Austen Quarry Stage 2 Extension Project

Response to Submissions

Major Project Application No. SSD-6084

January 2015

2.4.6 Clean Water Diversions

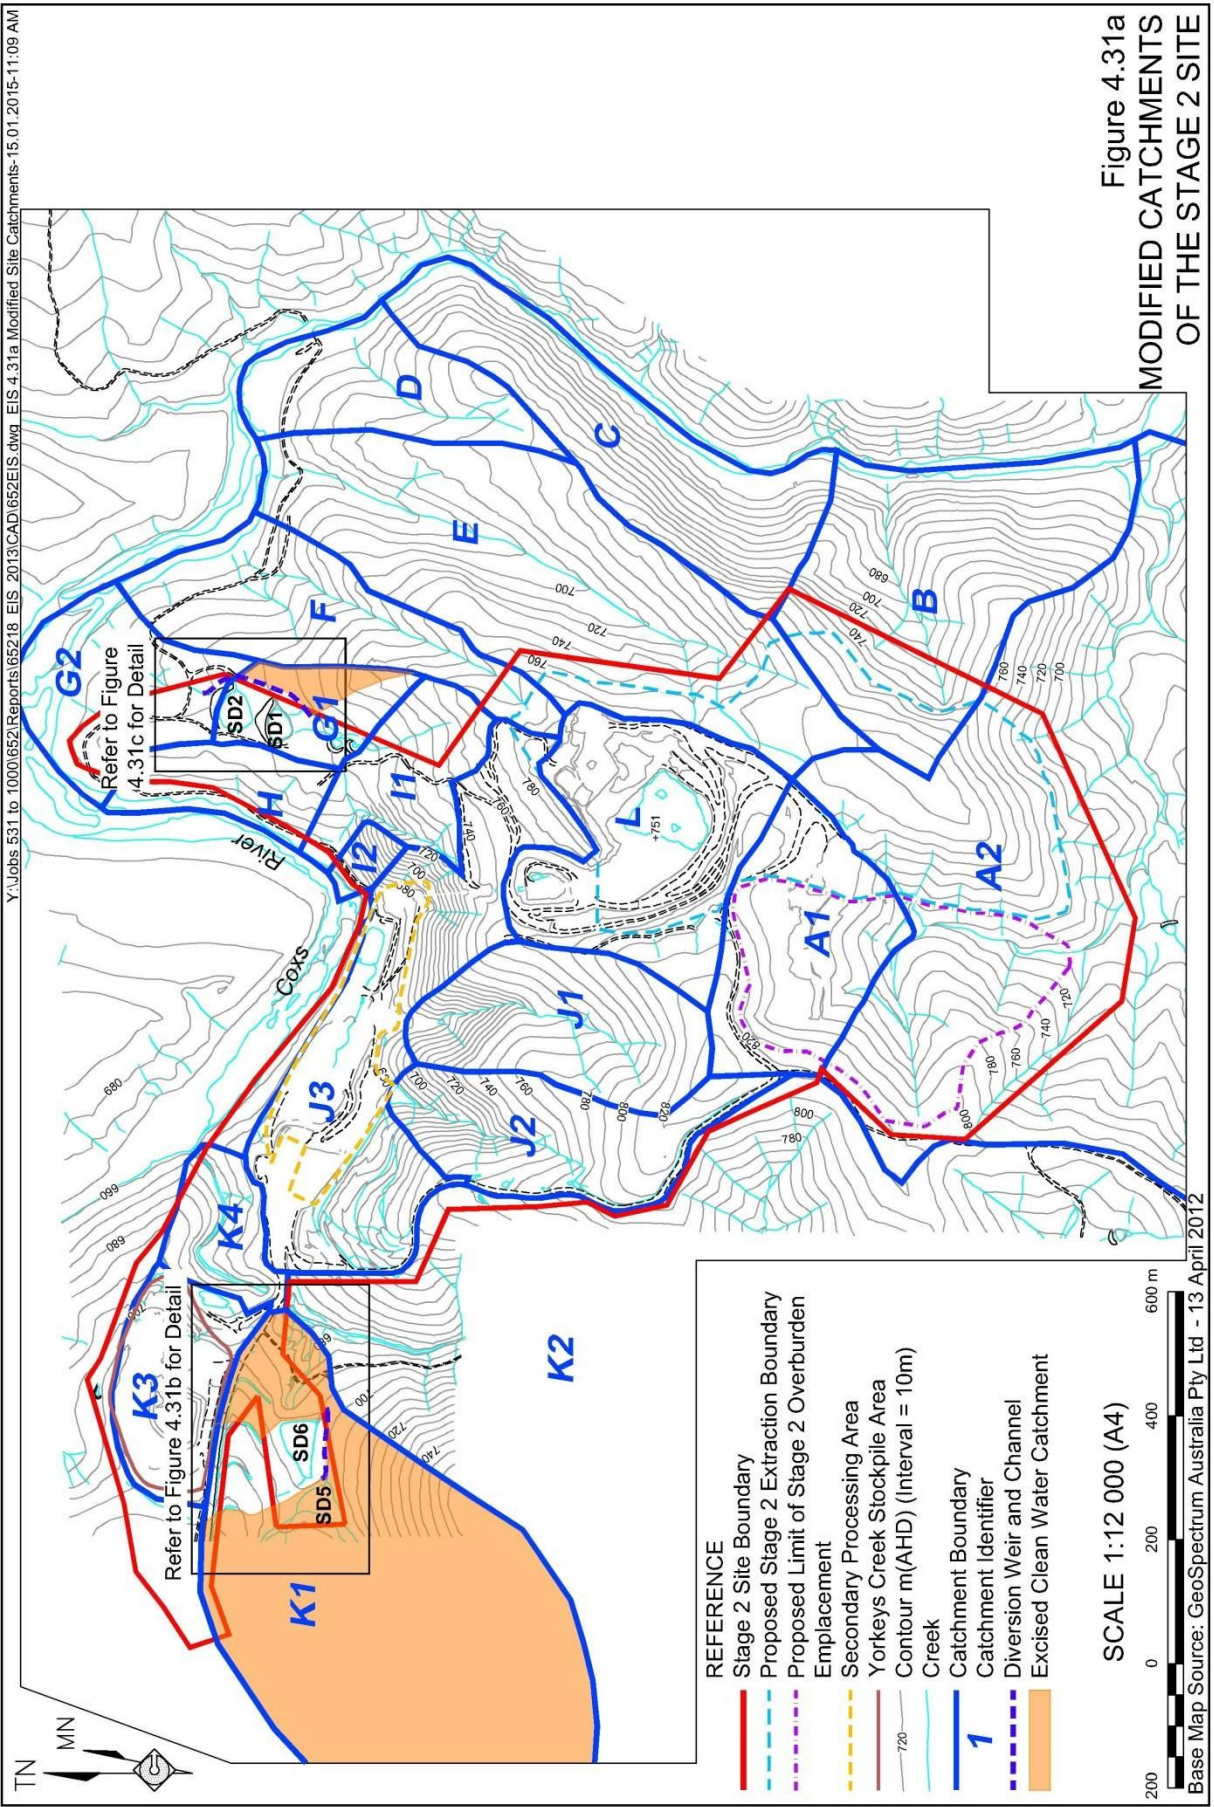
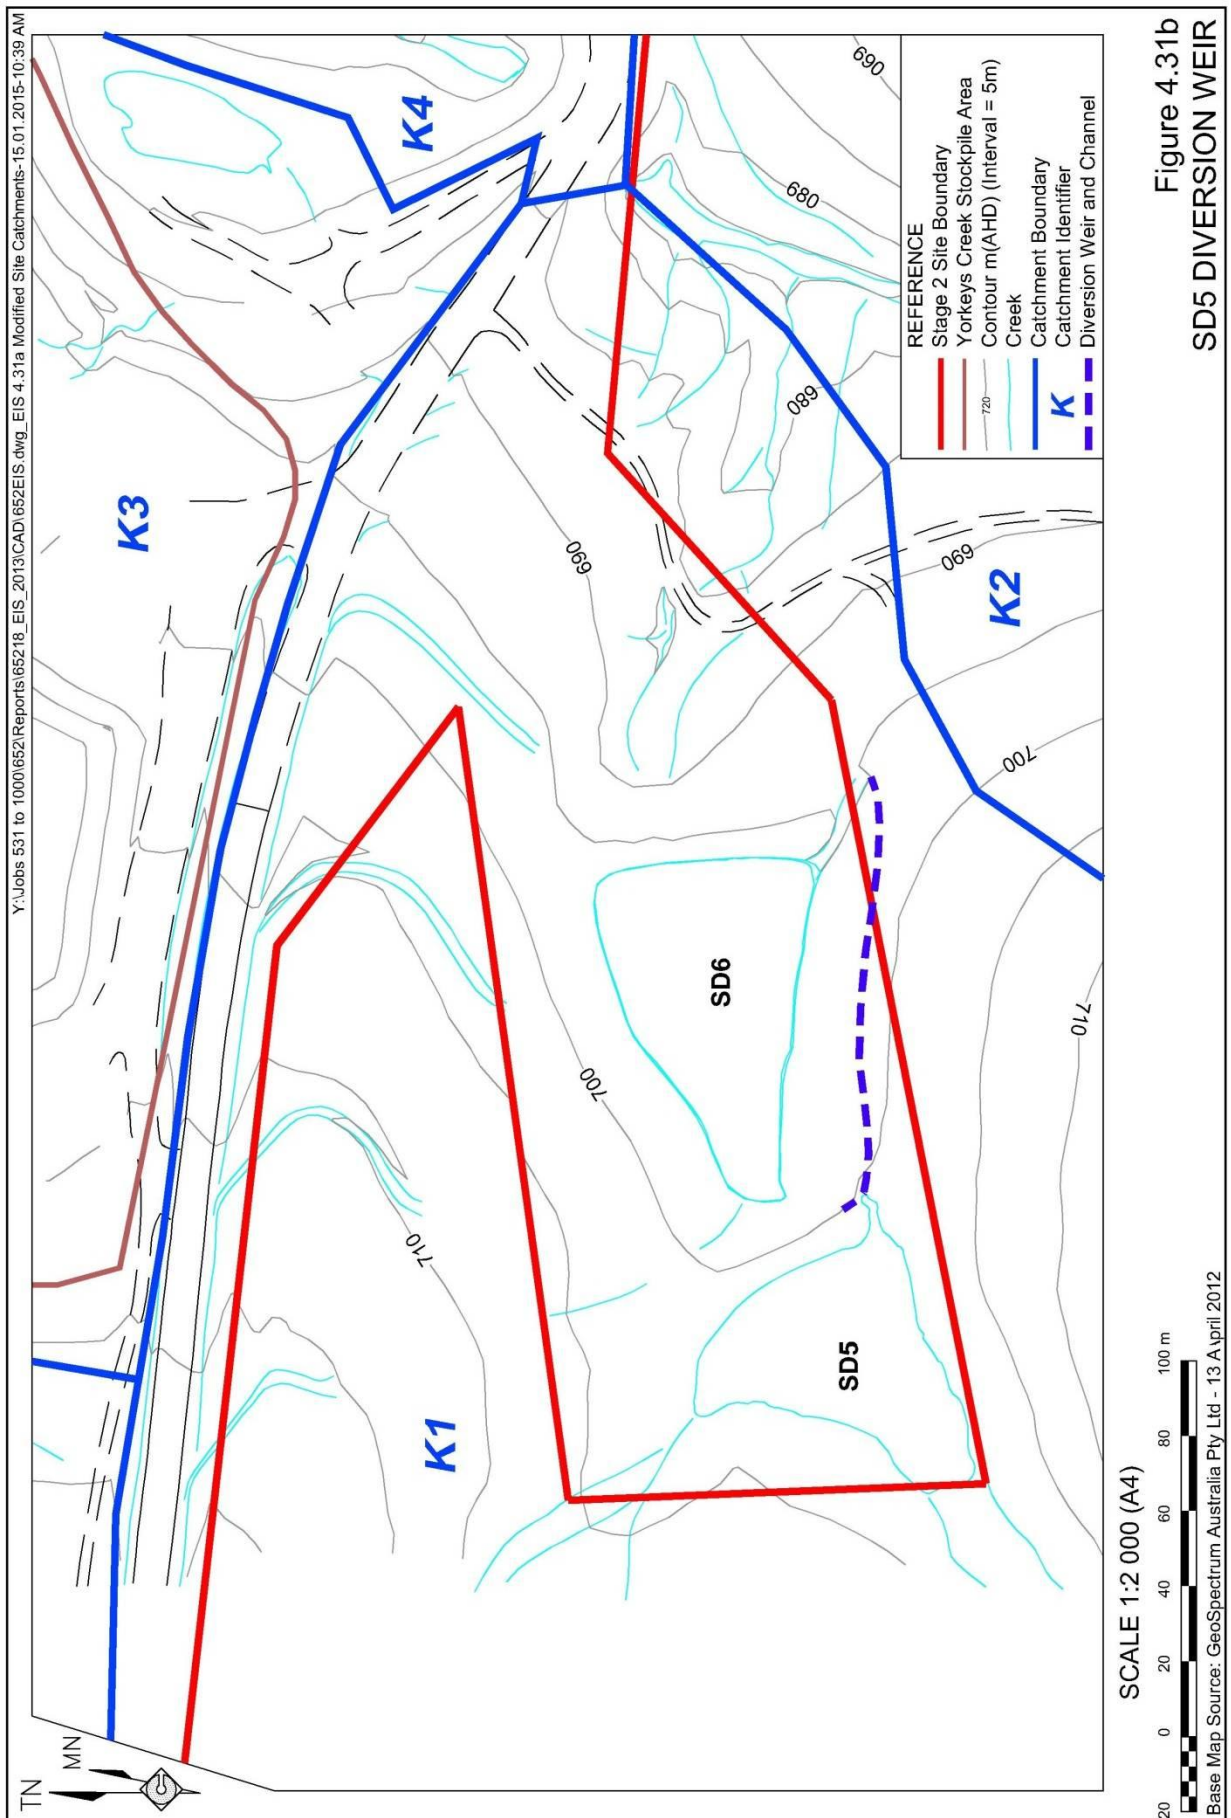
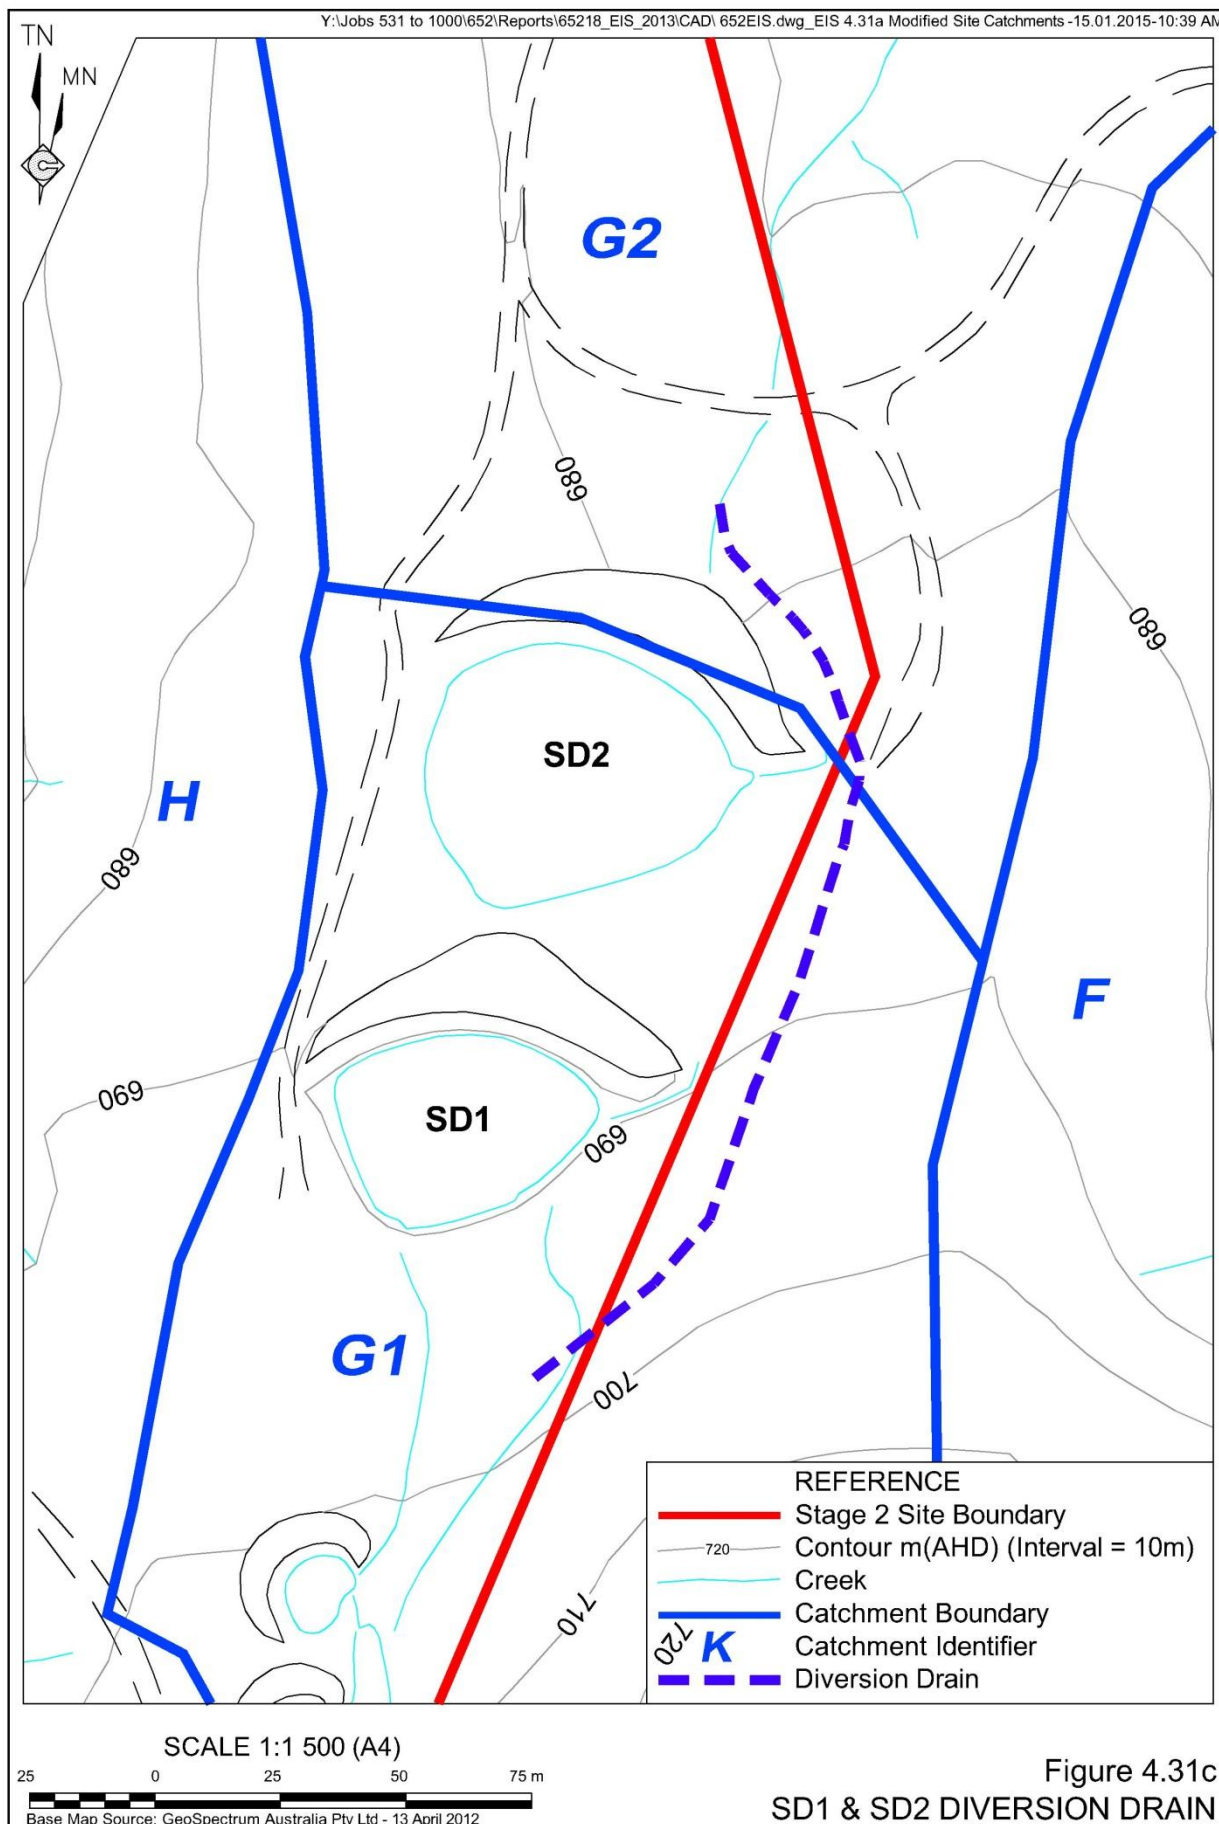
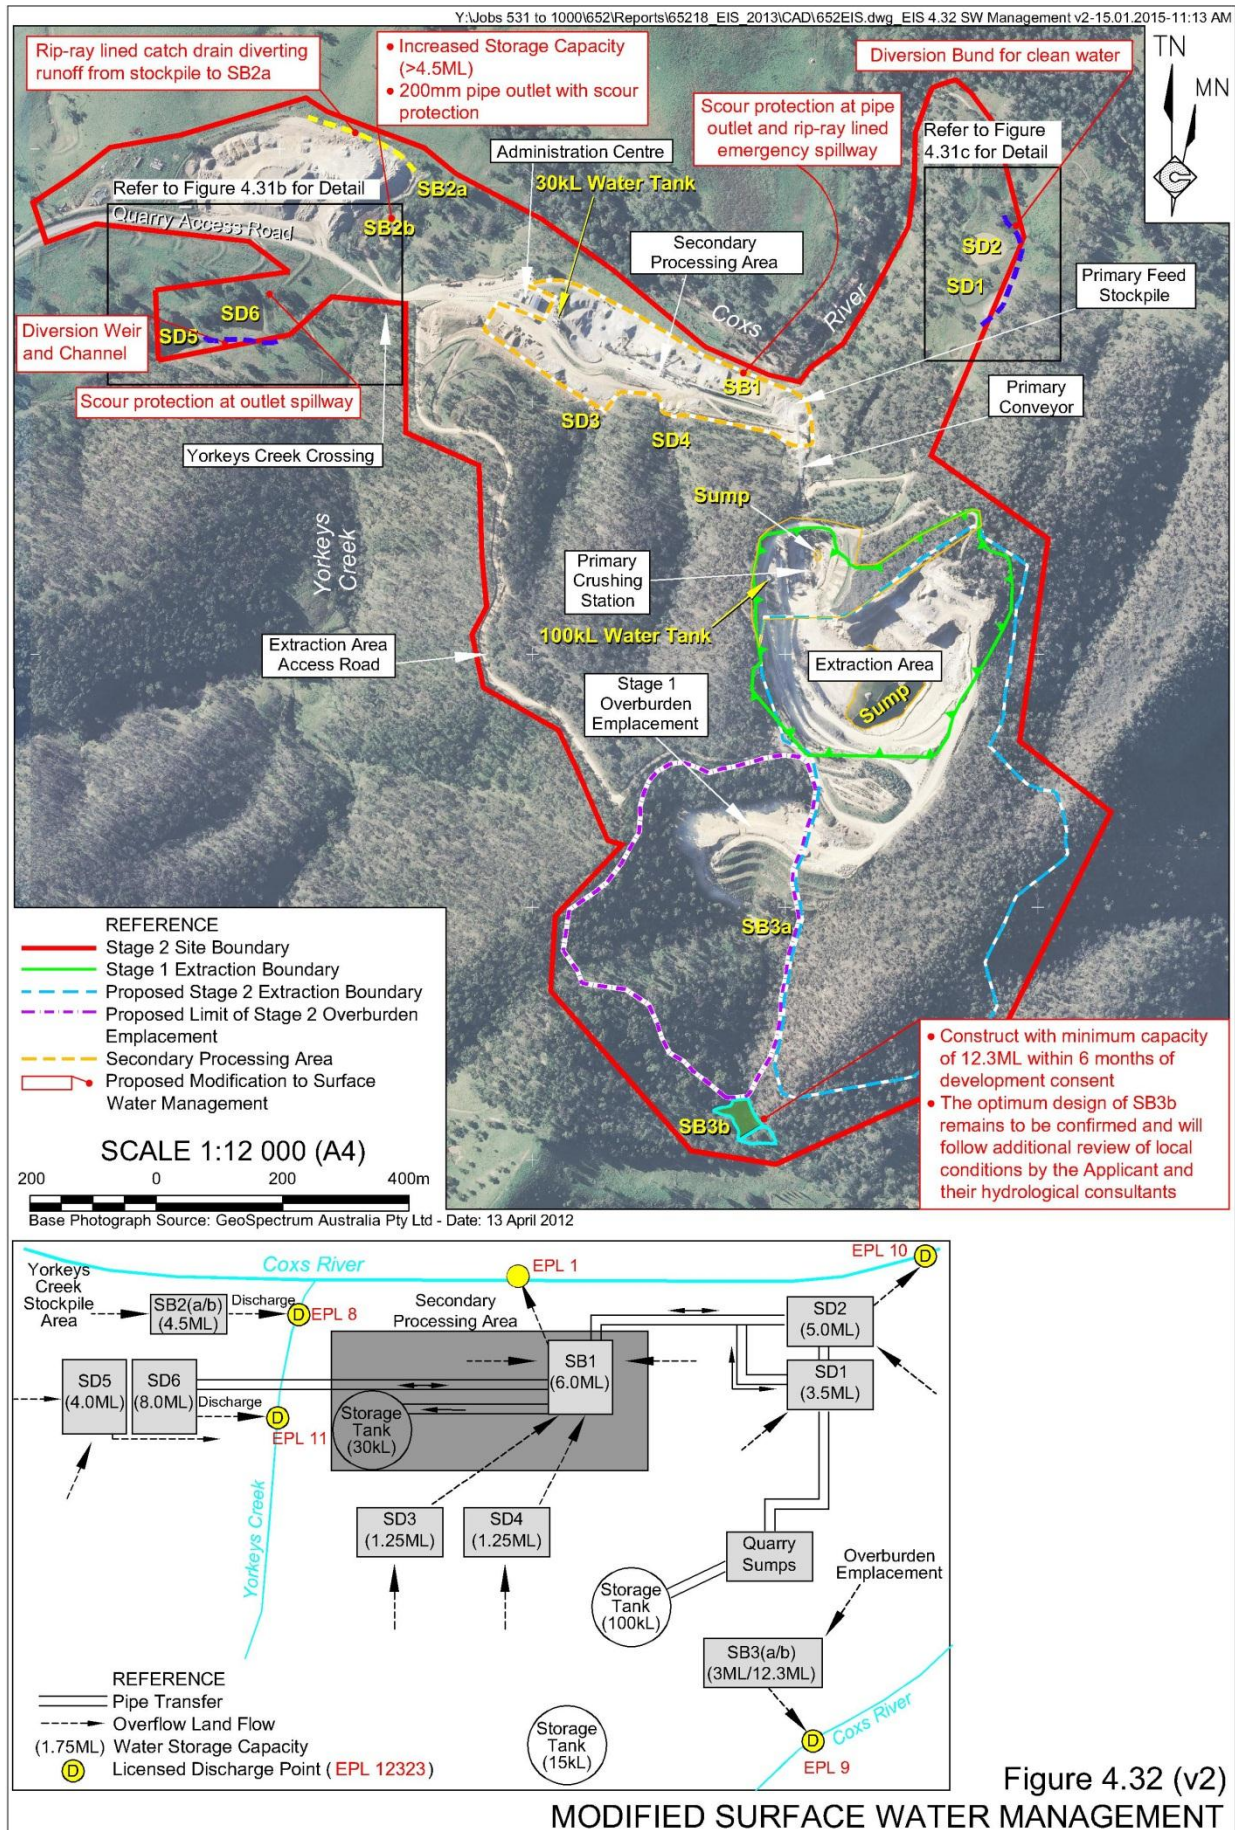
The submission seeks further information regarding the location of proposed clean water diversions so that it can assess these adequately.

As suggested in the meeting a more detailed description of the proposed location and discharge points for the clean water diversion drain could be provided, including revising Figure 4.32 to show clear diversion drain directions, rather than circles. A close up of the proposed diversion drain locations would help in this regard.

Natural topography has been utilised to separate catchment areas where practicable, including clean water and disturbed catchments. Where this is not suitable, perimeter or diversion bunds would be installed. **Figures 4.31(a to c)** and **4.32** of the EIS have been updated to more clearly display the location and direction of proposed clean water diversions.
